Remarks

Amendments to the Drawings:

Fig-3

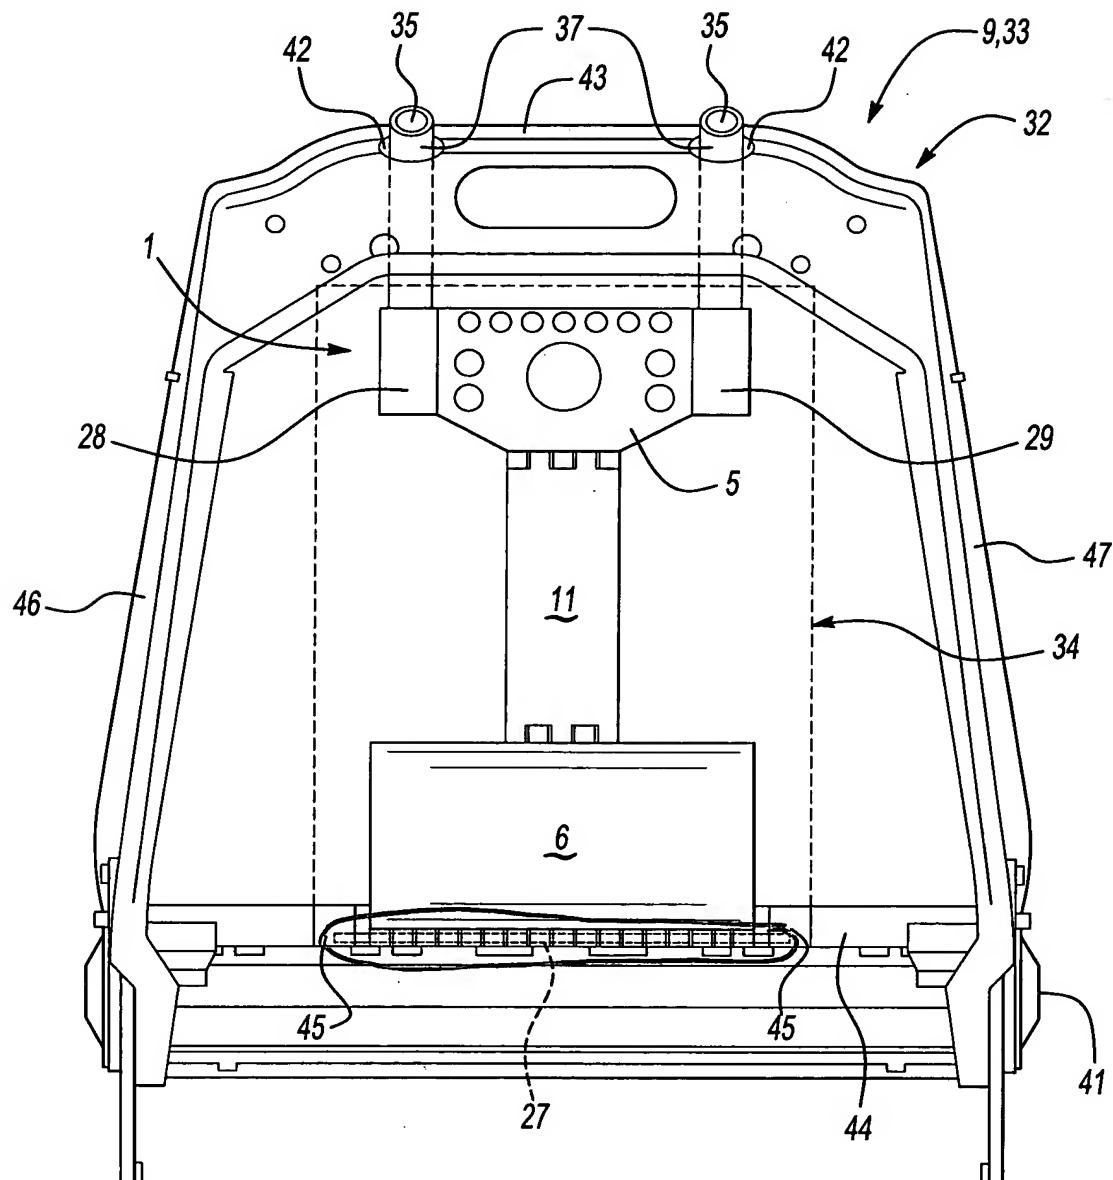
The drawings were also objected to under 37 C.F.R. § 1.83(a) as not showing every feature of the invention specified in the claims. Specifically, the Examiner stated that the limitation in claim 32 that “the impact panel is formed with decreasing width in the direction of the connection element” is not shown. Applicant has deleted this limitation from claim 32. As a result, the objection is believed to be cured.

Applicant has amended Figure 3 to show pivot shaft 27 held by shaft bearings 45 as disclosed in the paragraph beginning on page 12, line 7 of the original specification.
